Application for Licence Amendment

Licence Number	L8469/2010/2
Licence Holder	Galaxy Lithium Australia Limited
ACN	130 182 099
File Number	DER2014/001110-1
Premises	Ravensthorpe Spodumene Project Newdegate-Ravensthorpe RAVENSTHORPE WA 6346 Part of Mining Tenements M74/244, G74/13 and L74/46 as defined by the map in Schedule 1 and the coordinates in Schedule 2
Date of Report	09/08/2024
Decision	Revised licence granted

Manager, Resources Industries
INDUSTRY REGULATION (STATEWIDE DELIVERY)

Figure 3: Dust Monitoring Sites

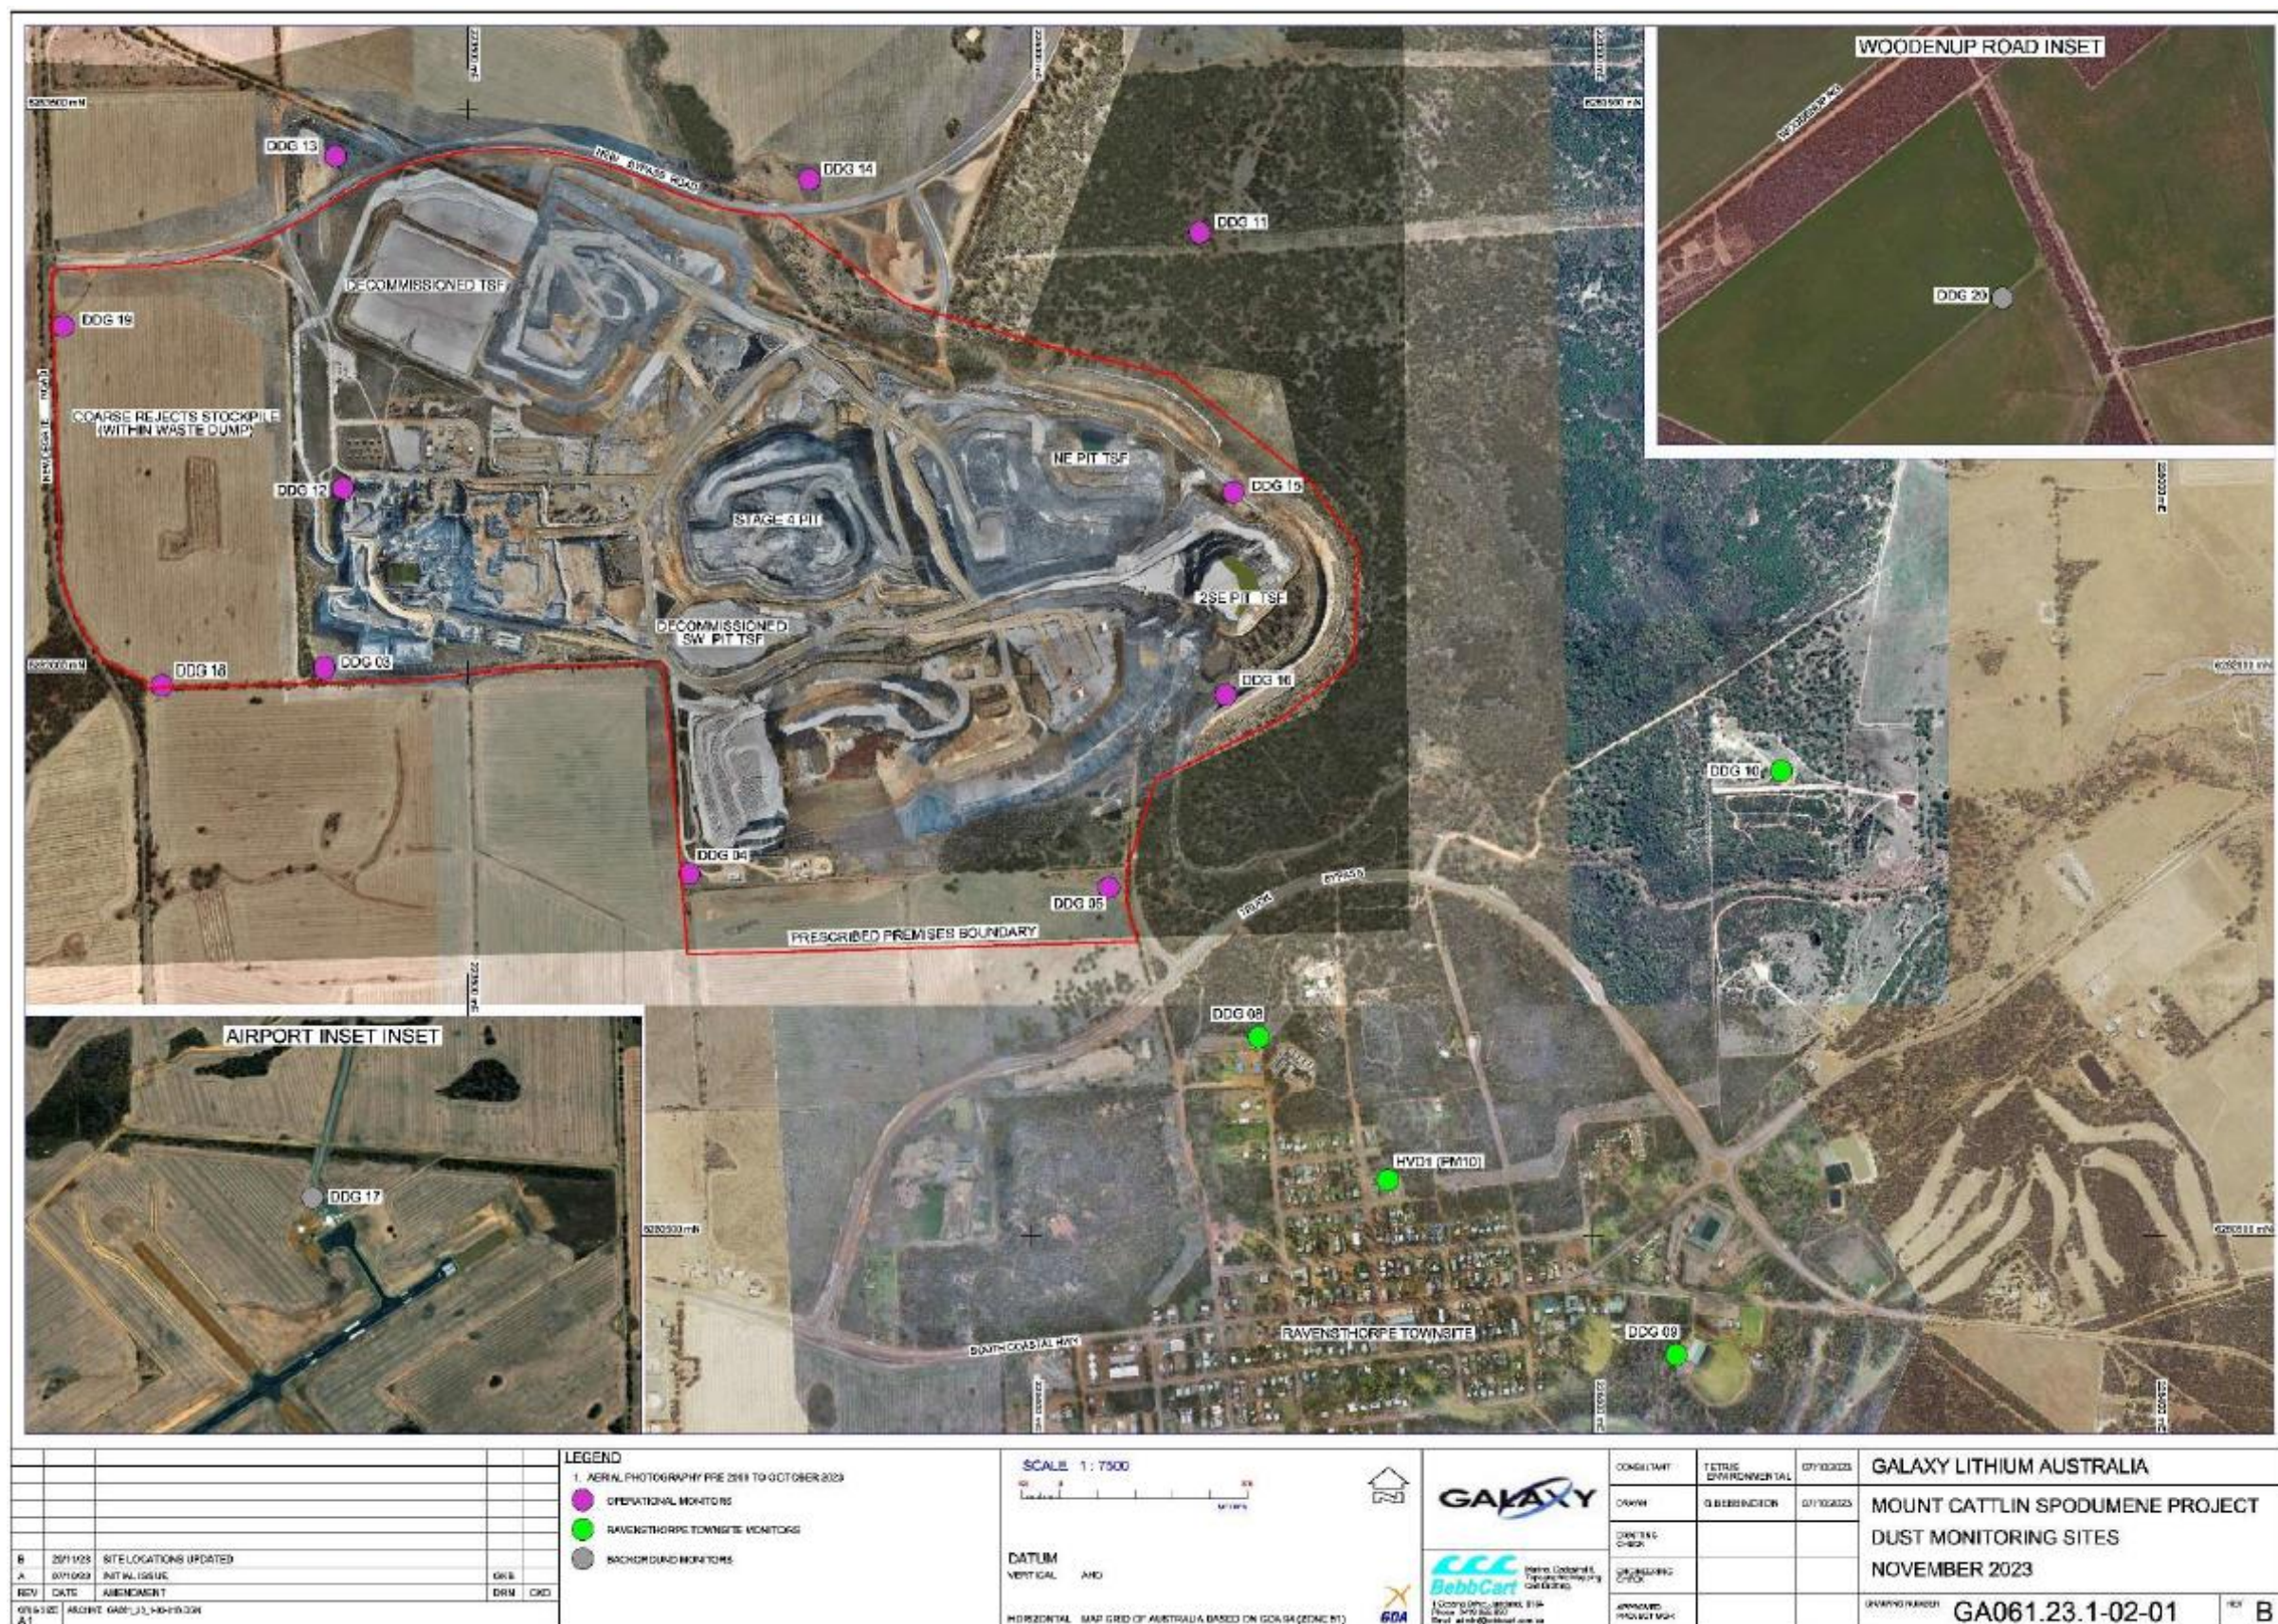
The Licence Holder has also proposed a change in dust monitoring sites (Figure 3) to better accommodate the change of works. Two new dust monitoring sites DDG 18 and DDG 19 were installed in November 2023 to monitor conditions associated with the increase of the WD2 footprint and the expansion of the prescribed premises boundary for the proposed coarse reject stockpile. DDG 01, DDG 02 and DDG 07 have also been removed and relocated to more relevant locations. DDG 01 (now renamed as DDG 13) was moved approximately 100 m away from the previous location in April 2022. DDG 02 (now renamed as DDG 22) was moved to the northwest boundary on 28 June 2024. DDG 07 (now renamed as DDG 11) was moved approximately 250 m from the previous location in February 2021. DDG 14, 15, 16 and 17 were installed in April 2022 and a summary of the locations are presented in Table 1 and Figure 3. These proposed locations have been accepted and will be added to the licence.

Note: DDG locations and IDs have changed as a result of this amendment. Updated locations and IDs are presented in Figure 3 Schedule 1 of Licence L8469/2010/2.

Figure 5: Annual average recorded dust deposition results from November 2020 to June 2022 (sourced from ETA 2023)

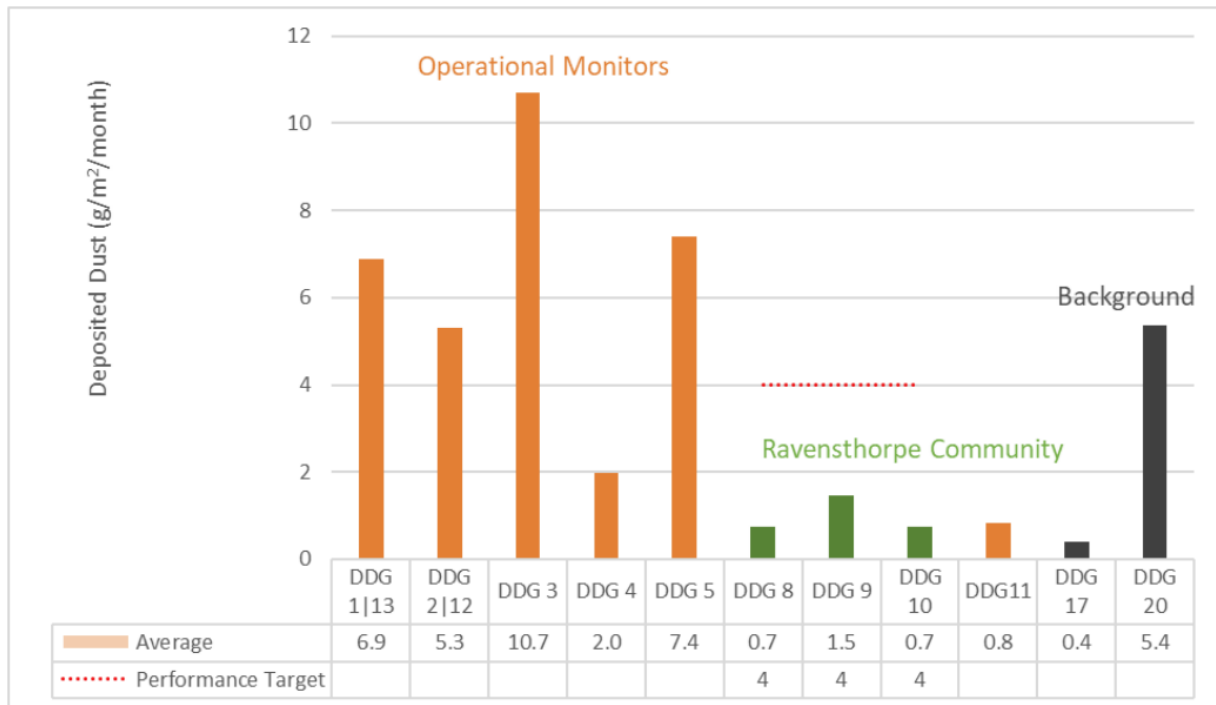
Technical advice has indicated that the use of ambient air quality criteria as limits in licence conditions is not practical due to the evidence of multiple fugitive sources of dust in the local environment. Evidence of multiple dust sources is demonstrated in Figure 5 and Figure 6 through the high concentrations of dust within the background DDG (DDG 20). DDG 20 background monitor is located on agricultural property 17 km north of the Mt Cattlin Operations and appears to be impacted by seasonal farming activities (harvesting, ploughing of soil) and other localised sources (ETA 2024).

The Department has amended condition 3.5.1 to remove the word “limit” and replaced with “target” for the PM₁₀ parameter. The word change implementation ensures that the Licence Holder does not have to notify a breach of a limit as per condition 4.3.1 if dust monitoring station (HV01) reports a PM₁₀ concentration of 50 µg/m³ over a 24-hour period. The Department has also added condition 3.5.2 to require the Licence Holder to conduct an investigation for the potential causes for the target value (50 µg/m³) to exceed and report the findings to the Department within 3 months of exceeding the target.

Figure 10: NE Pit TSF with installed monitoring bores (orange) and proposed decant bore locations (green)

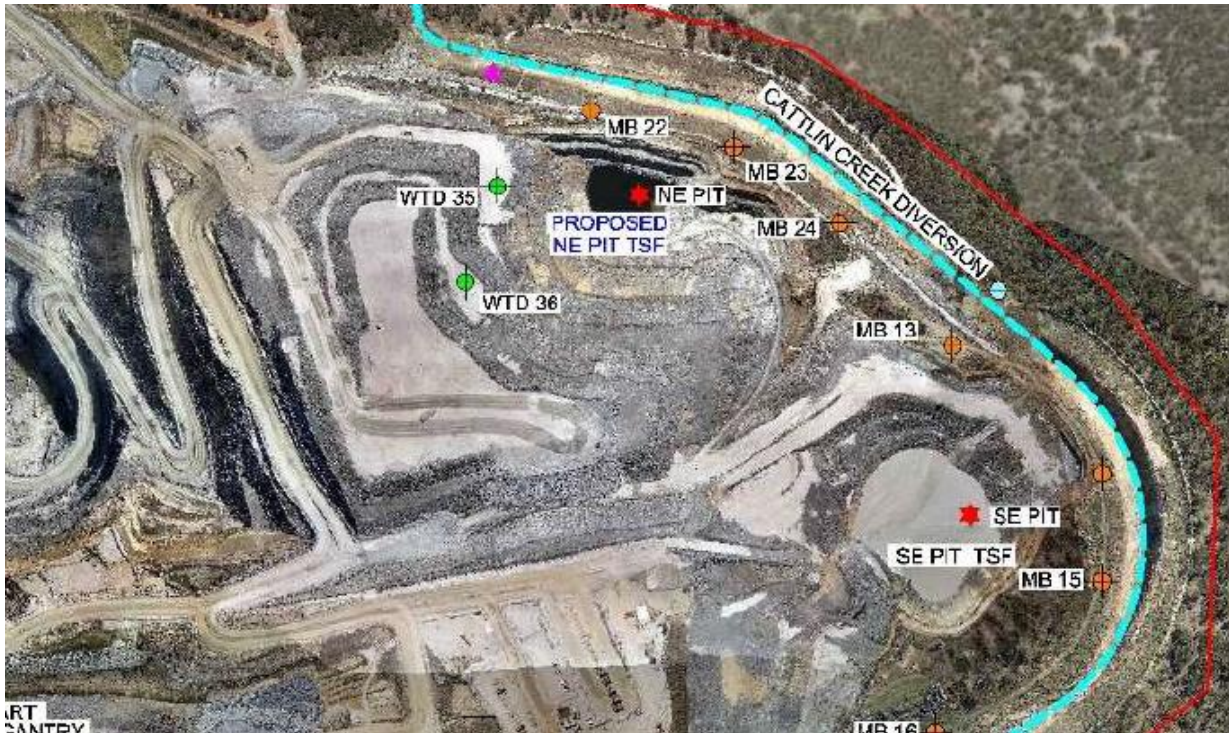
To mitigate the effects of groundwater mounding caused by the leaching of tailings into the groundwater the Licence Holder has proposed a decant water recovery system involving two decant recovery bores (WTD35 and WTD36) (Figure 10) located down the assumed hydraulic gradient through a waste dump (Figure 11) next to the NE Pit TSF. The TSF design takes advantage of an existing backfill area (waste dump), which will serve as a containment barrier for the proposed NE Pit TSF.

The Licence Holder has also installed groundwater monitoring bores (MB22, MB23 and MB24) in October 2023 along the northeastern boundary of the NE Pit (see Figure 10) to allow monitoring of the groundwater surrounding the in-pit TSF for signs of seepage impacts.

The applicant's proposed management measures i.e. monitoring of groundwater levels and quality within the constructed monitoring bores surrounding the NE In -Pit TSF ((MB22 to MB24) will be added to the conditions of the licence.

Figure 13: Groundwater contours for December 2022 (Source: Rockwater 2023)

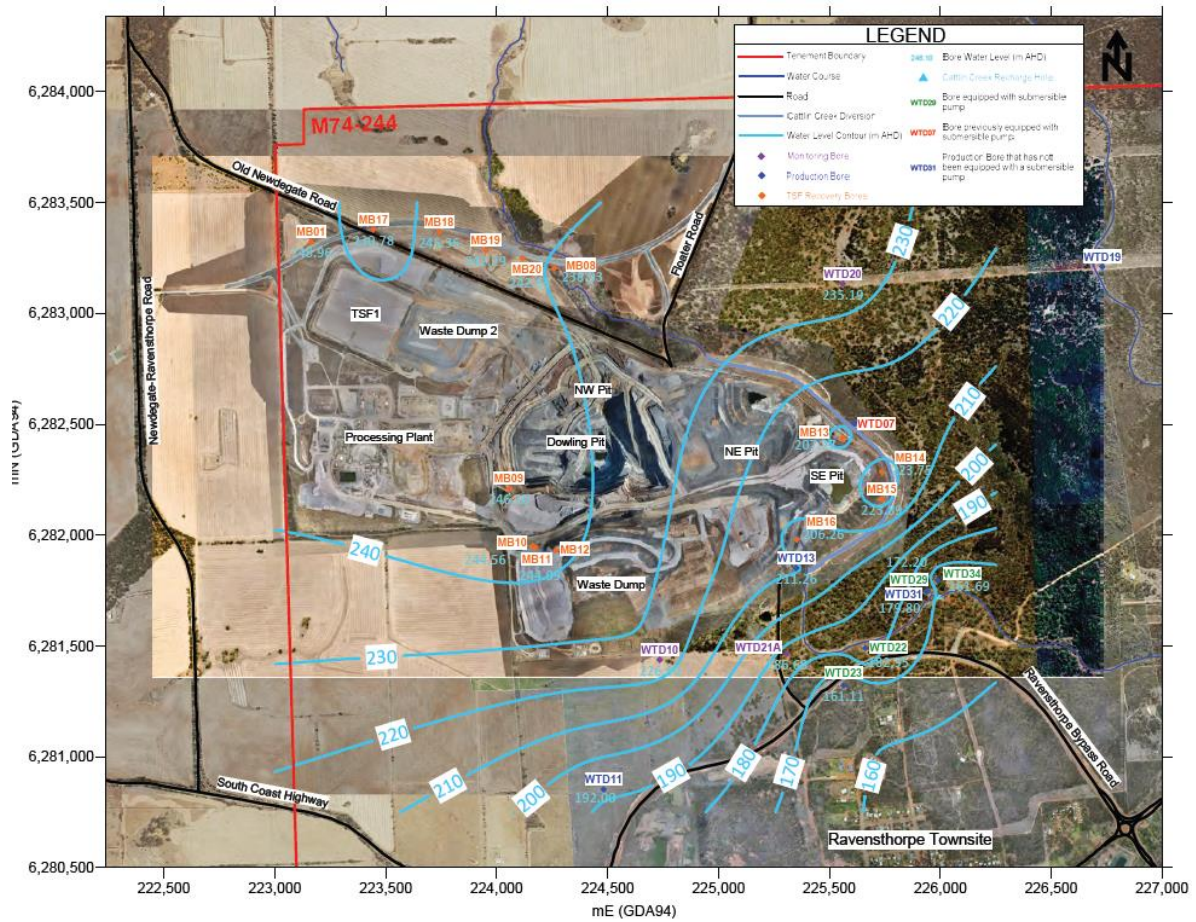
To assist in the determination of the potential for groundwater mounding to occur a review of surrounding groundwater monitoring bore results at the active 2SE Pit TSF (MB13 to MB16) was undertaken to investigate the effect that deposition of the high water content tailings had on groundwater levels surrounding the in-pit TSF. Measured groundwater standing water level (SWL) in surrounding monitoring bores to 2SE Pit TSF reported a groundwater level rise of approximately 10 -15 m since tailings were deposited in March 2022. Figure 13 presents the groundwater mounding that has occurred surrounding the 2SE Pit TSF specifically at MB13, MB14 and MB15 recording high groundwater levels when compared with the surrounding groundwater environment. It is noted that groundwater levels appear to have plateaued and are unchanged by seasonal effects and tailings deposition in monitoring bores MB13 to MB16 as presented in Figure 14.

Figure 14: Measured SWL around 2SE Pit TSF (Information sourced from Rockwater 2023)

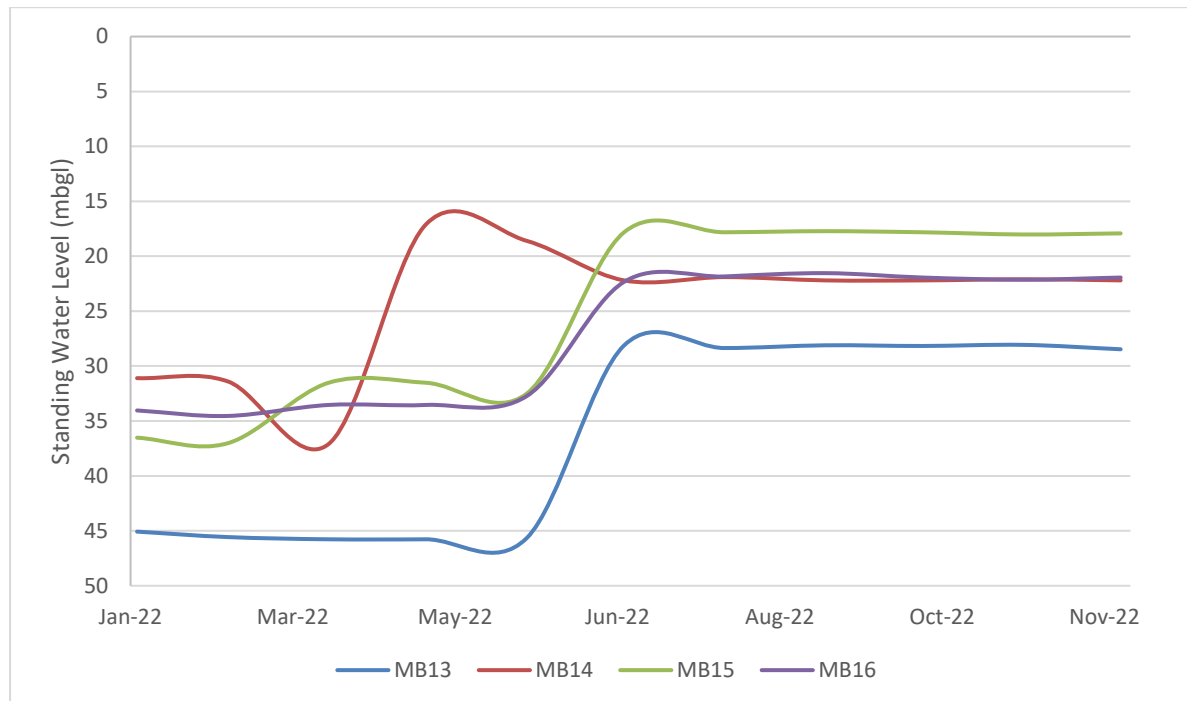
As shown by the groundwater monitoring data around the existing 2SE Pit TSF the high-water content of the tailings has resulted in a rise in groundwater levels of approximately 10 meters. The high water- content of the tailings being discharged into the proposed NE In-Pit TSF therefore increases the risk that groundwater mounding near the new in-pit TSF may occur.

As a result of the high-water content of the tailings (which was unknown at the time of the assessment for the existing 2SE Pit TSF), additional regulatory controls have been deemed necessary to be added to the licence in the form of a standing water level target (6 mbgl) and limit (3 mbgl) on the groundwater monitoring bores surrounding the in-pit TFS. The requirement for a seepage management plan to be implemented if the trigger level is reached has also been added to the licence. These additional regulatory controls will ensure that impacts to vegetation does not occur.
